**COMMITTEE OF ADJUSTMENT**

**NOTICE OF PUBLIC HEARING**  
**Minor Variance**

<b>APPLICATION NO.:</b>	<b>AN/A-22:180</b>	<b>SUBJECT PROPERTY:</b>	64 LOVERS LANE, ANCASTER
<b>ZONE:</b>	“ER” (Existing Residential)	<b>ZONING BY-LAW:</b>	Zoning By-law 87-57, as Amended 18-105

<b>FOR COMMITTEE OF ADJUSTMENT</b>		
PROJECT: <b>KANCKO RESIDENCE</b> 64 LOVERS LANE ANCASTER, ONTARIO		
SHEET TITLE: <b>PROPOSED SITE PLAN</b> 3/32"=1'-0"		
SCALE:	DATE:	
AS NOTED	JUNE, 2021	
DRAWN BY:	SHEET NO.:	
AWG		
CHECKED BY:		
AWG		<b>SP1</b>
FILE NO.:		
MK-21-06		01 of 06

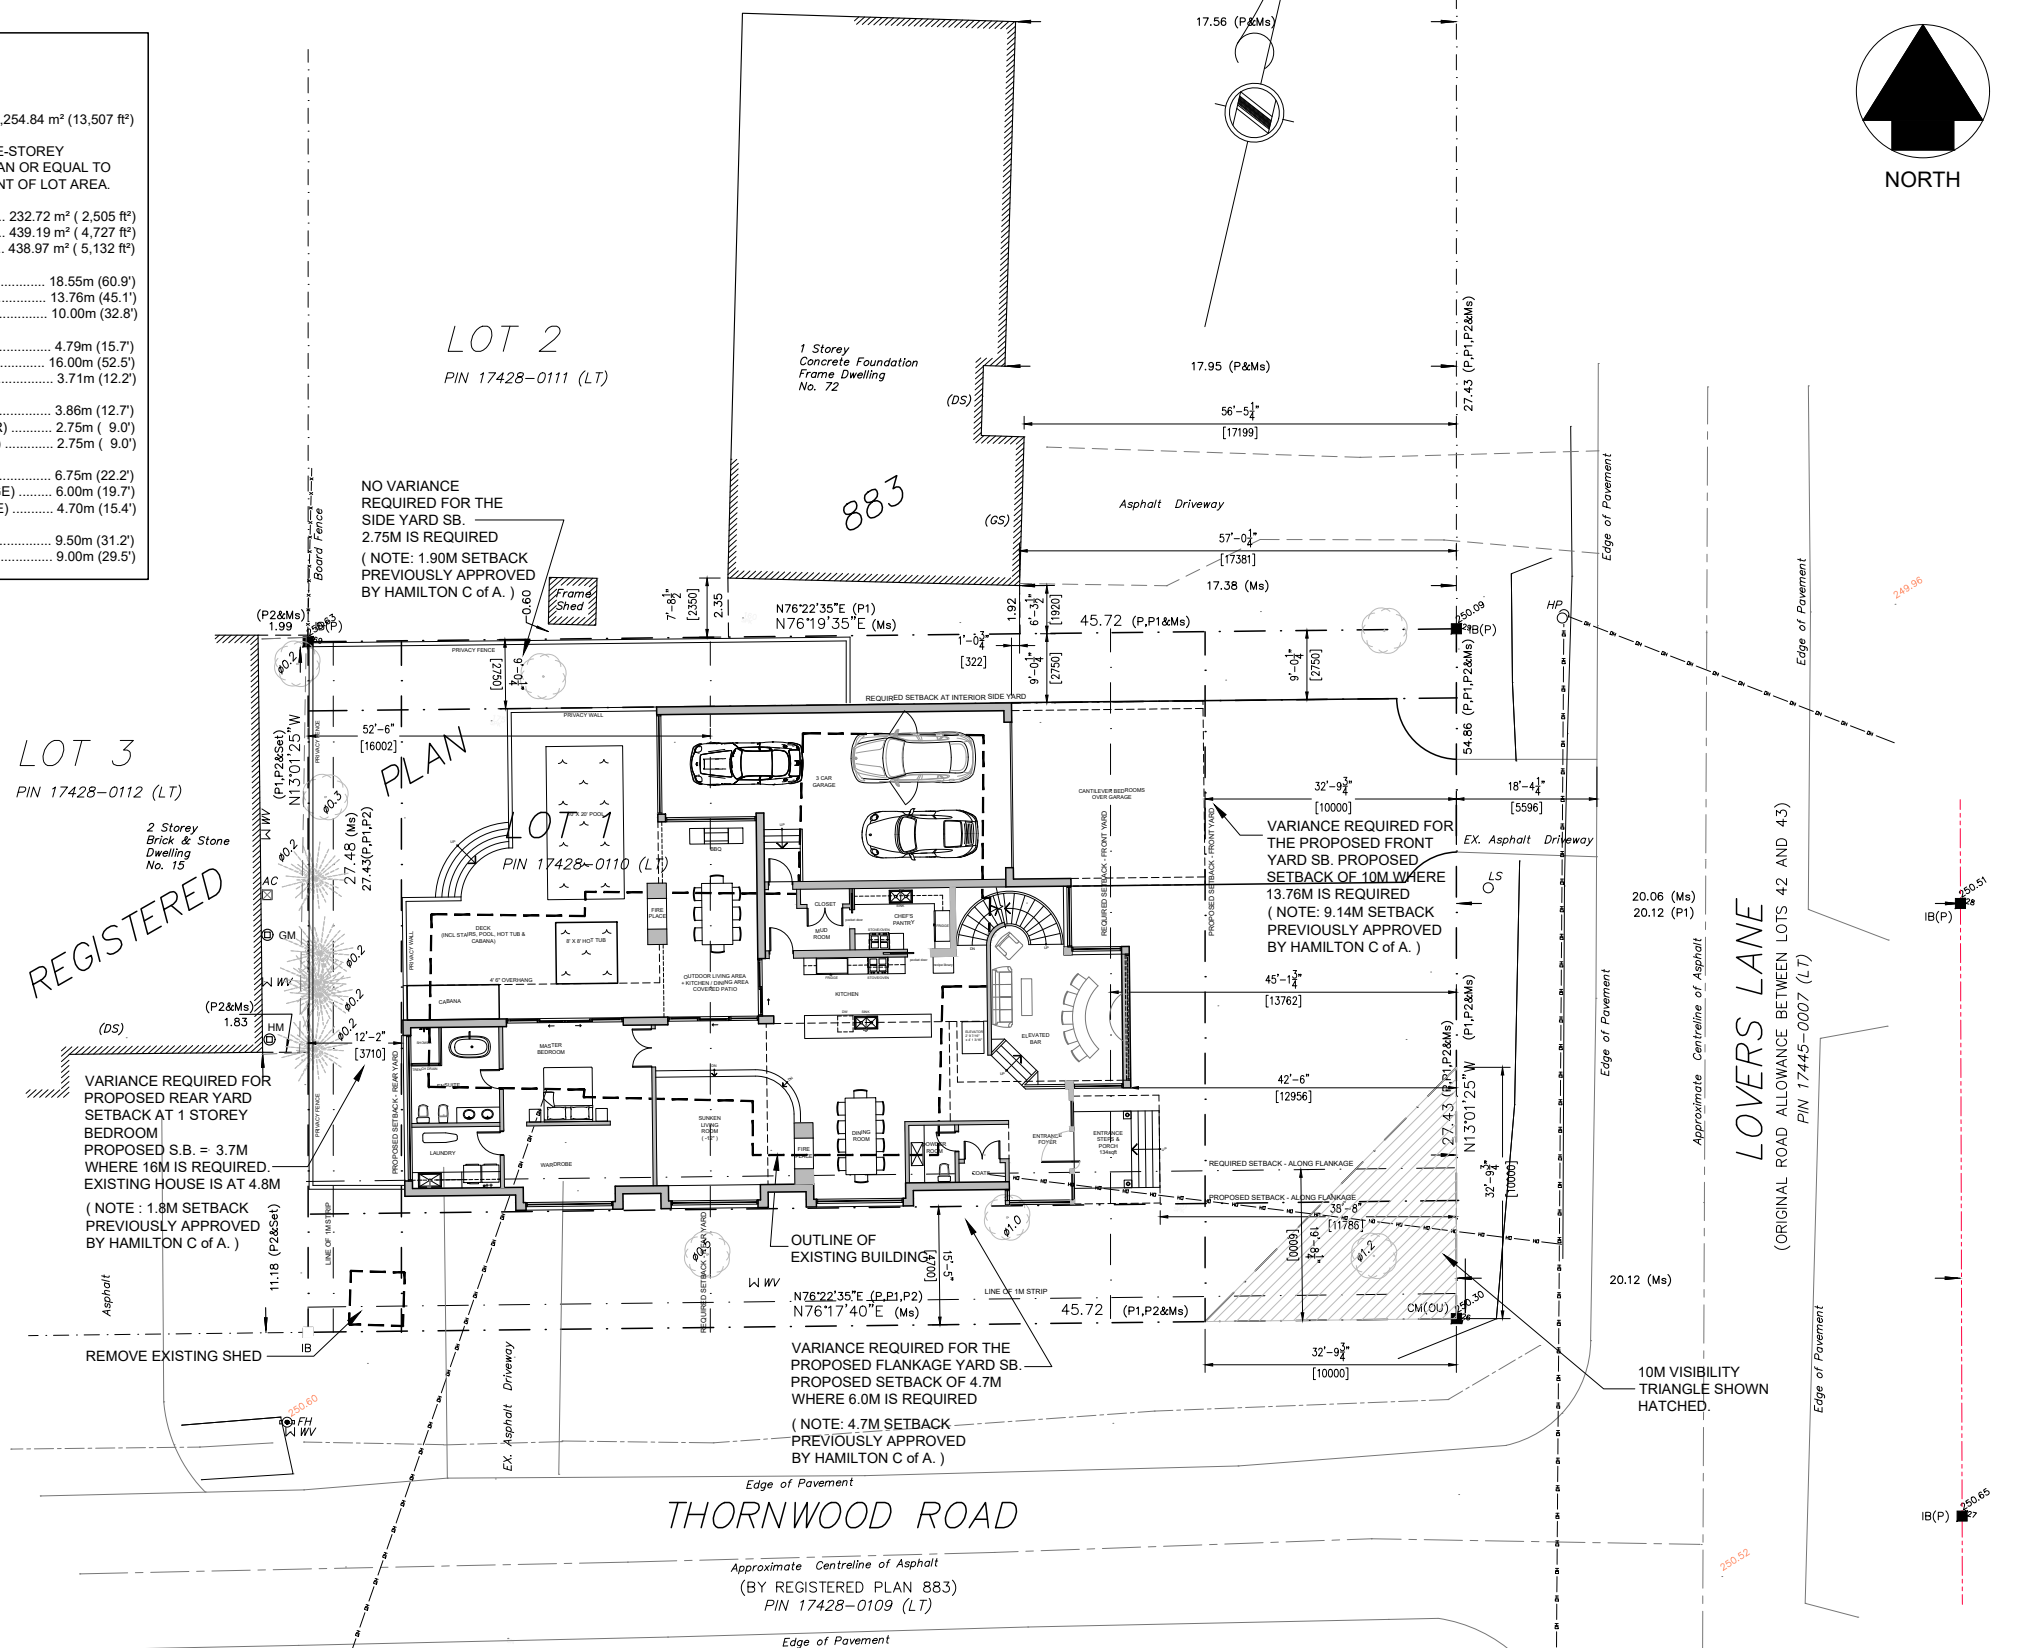
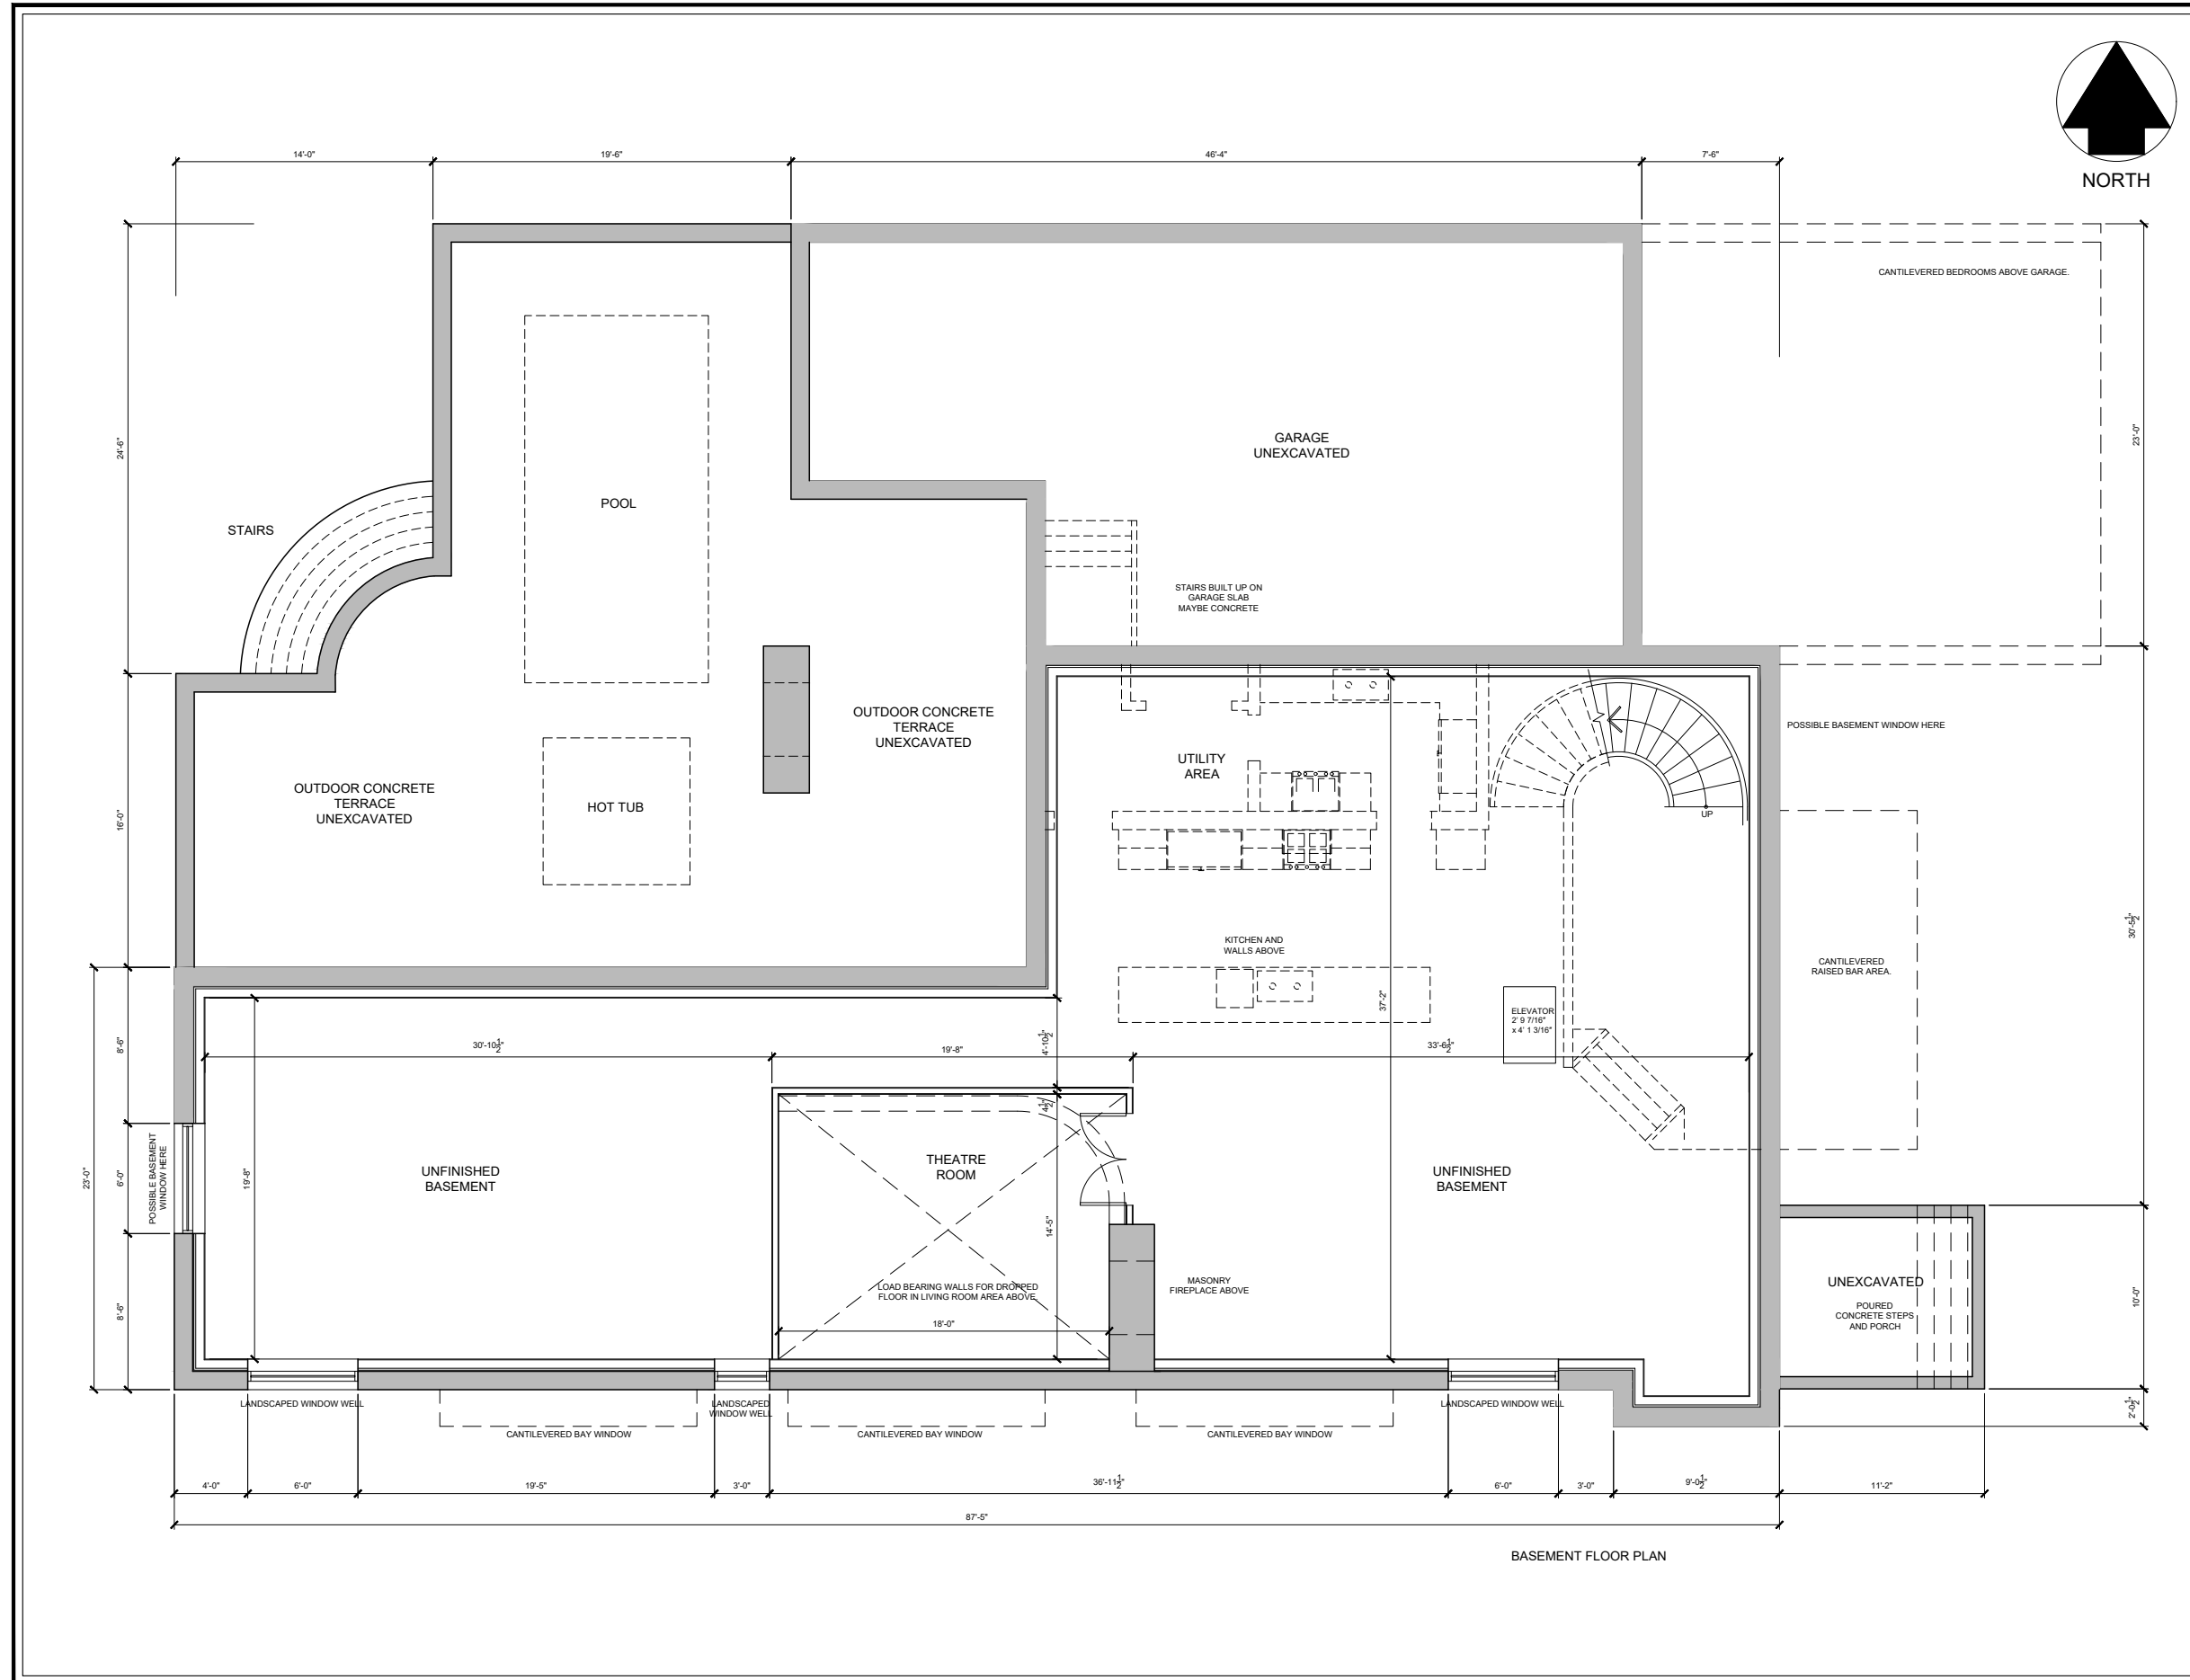
1. Please note that the Site Plan statistics indicate a total proposed lot coverage of 38 percent, whereas a maximum lot coverage of 35 percent is permitted. It is noted that the area of all buildings is indicated as 438.97 square metres, which is 34.98 percent of the area of the lot (i.e. lot area indicated as 1254.84 square metres). Additional variances shall be required if compliance with Section 10.3.3 is not possible.
2. It is unclear from the Site Plan provided if a minimum of one metre within the norhtelry side yard is to be unobstructed and shall not contain structures, walkways, sidewalks, hard surfaced

3. Specific details regarding the projection of sills, cornices, bay windows etc. of the proposed single family dwelling were not indicated on the submitted site plan. Please note that should the variance requested to permit a reduced minimum front, side and rear yard setback be approved, as per Section 7.12(a), sills, cornices, bay windows etc. shall be permitted to project into the new minimum yard(s) a distance of not more than 0.60 metres. Additional variances may be required if compliance with Section 7.12(a) is not possible.

4. Specific details regarding the projection of eaves/gutters of the proposed single family dwelling were not indicated on the submitted site plan. Please note that should the variance requested to permit a reduced minimum front, side and rear yard setback be approved, as per Section 7.12(b), eaves and gutters shall be permitted to project into the new minimum side yard a distance of not more than 0.60 metres, or into the minimum front yard and rear yard a distance of not more than 1.5 metres. Additional variances may be required if compliance with Section 7.12(b) is not possible.

6. Please note that as per Section 7.13(a), on any corner lot in any Zone, no obstruction, whether permanent or temporary, that blocks vision between a height of 75 centimetres and 2.4 metres above the centre line grade of the street, is permitted within a daylighting triangle of 10 metres. Additional variances may be required if compliance with Section 7.13(a) is not possible.

7. Please note that the percentage of the area of the at-grade parking area has not been indicated; therefore, compliance with Section 7.14(a)(x) could not be confirmed.

8. Please note that should the variance requested to permit a reduced minimum rear yard setback, the proposed accessory structure (in-ground pool) will not be located in a required rear yard, and will therefore comply with Section 7.18(a)(vi). However, the distance from the proposed in-ground pool, which is indicated as 8.58 square metres (i.e. 200 square feet), to the rear lot line has not been indicated. As per Section 7.18(a)(vi)(A), accessory buildings in excess of 12 square metres ground floor area shall not be less than 7.5 metres from the rear lot line for any lot located in an Existing Residential "ER" Zone. Additional variances may be required if compliance with Section 7.18(a)(vi)(A) is not possible.

9. Specific details regarding the proposed parking spaces on the lot have not been provided, however, it appears a minimum of two (2) parking spaces, as required by Section 7.14(b)(i)(A), can be accommodated in the proposed garage and driveway. Additional variances may be required if compliance with Section 7.14 is not possible.

10. Please note that elevation drawings were not provided to confirm the height of the proposed accessory structure(s). Please note that as per Section 7.18(a)(iv), the maximum height for an accessory building is 4.5 metres. Additional variances may be required if compliance with Section 7.18(a)(iv) is not possible.
